PREAPPLICATION REVIEW REQUEST

PROJECT NAME Portable Classroom Project for Church on the Mountain

- General Plan Amendment Specific Plan Conditional Use Permit Director Review
 Other Use Permit Modification 24-001

MECHANICAL FLOOR PLAN 1/4" = 1'-0"

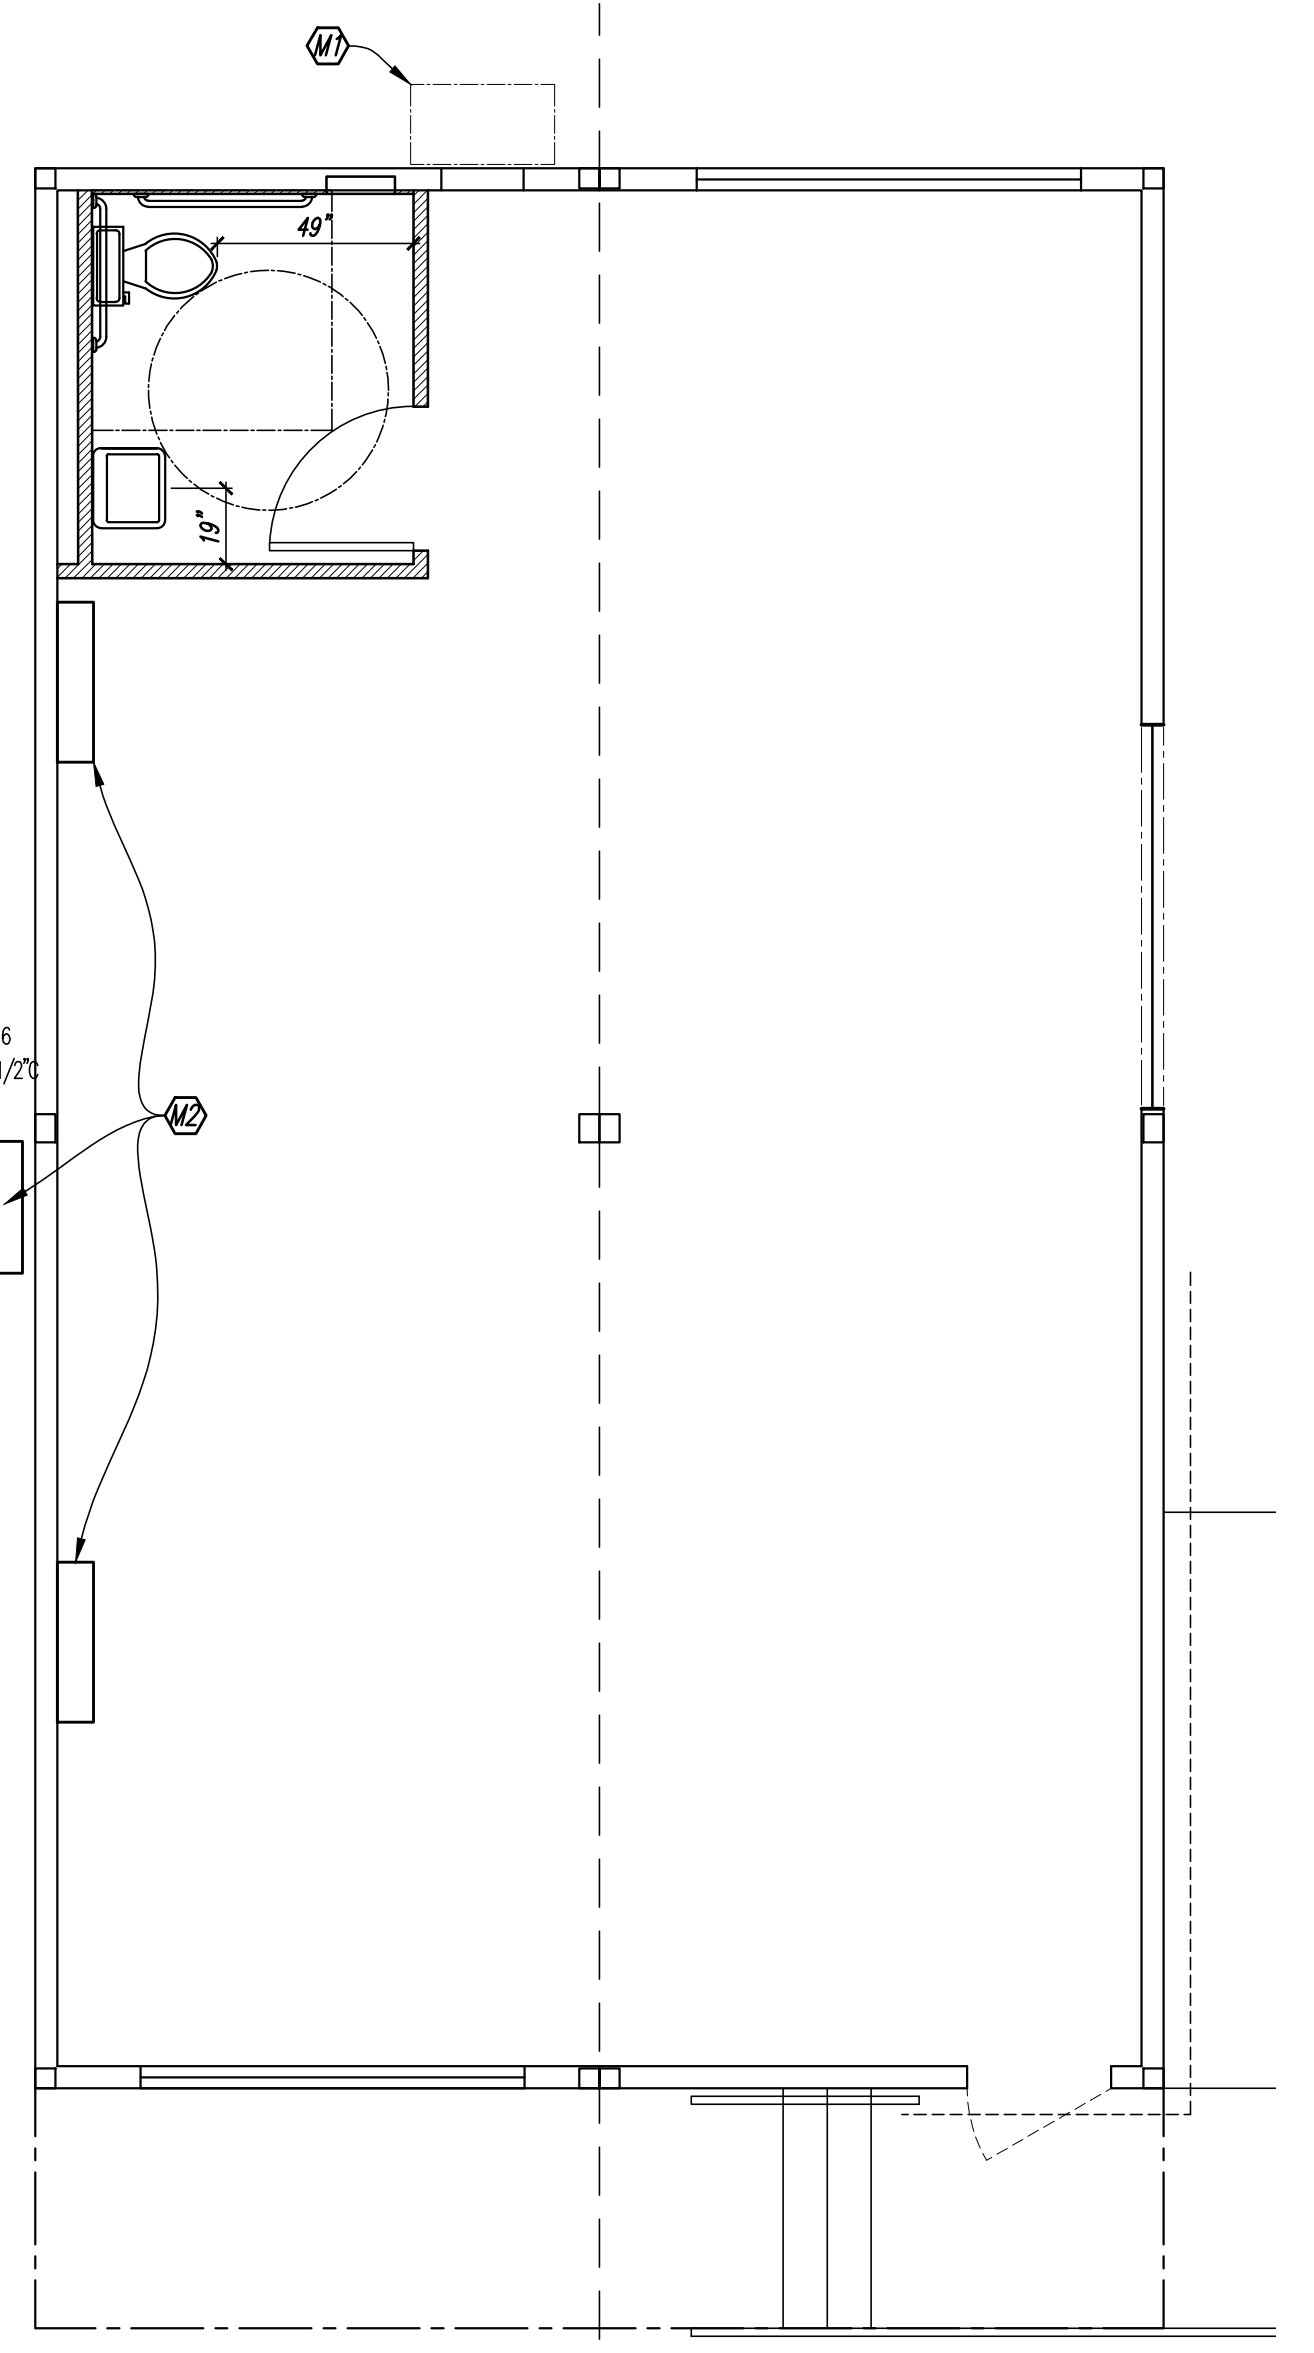
Our subject Use Permit Modification 24-001 was approved with power to the new portable classroom planned and shown as running underground from the existing power pole to the electrical meter / main disconnect location along the south wall. We respectfully request that we be allowed to run an overhead service line from said power pole to a standard "mast" at said meter/disconnect location as shown on the attached Mechanical/Plumbing/Electrical Construction Document, Dwg. MEP1.0, revised 11/7/24.

The motivation for the change is economical cost savings. Insofar as there are already two sets of overhead power lines crossing the property, it is felt that this service drop will "fit right in" and not substantially detract aesthetically to the view from the street nor increase substantially increase the fire hazard, though it is not zero.

- E1. Mast, Elec. Meter & Main disconnect location. NEMA 3R enclosure, 200A switch, feed direct into back of (E) sub-panel. Provide permanent markers for:
 - a. Max. available Fault Current per CEC 110.24(A)
 - b. Arc flash warning label per CEC 110.16
 - c. Main Service Disconnect per CEC 230.70(B)
 - d. Ratings and Location of the grounding electrode per CEC 250.50
- E2. (E) sub-panel location within modular unit, see sub-panel sch. this sheet.
- E3. LED outdoor walpak Westgate WML-80W-40K w WML-SH2 hood for Dark Sky Ord. compli. 120-277V, 11600 Lumens, 40K color, dark bronze alum., typ of 2.
- E4. New power service from this PP, overhead to south wall of portable classroom. Mast to meet SCE standard details & req'ts.
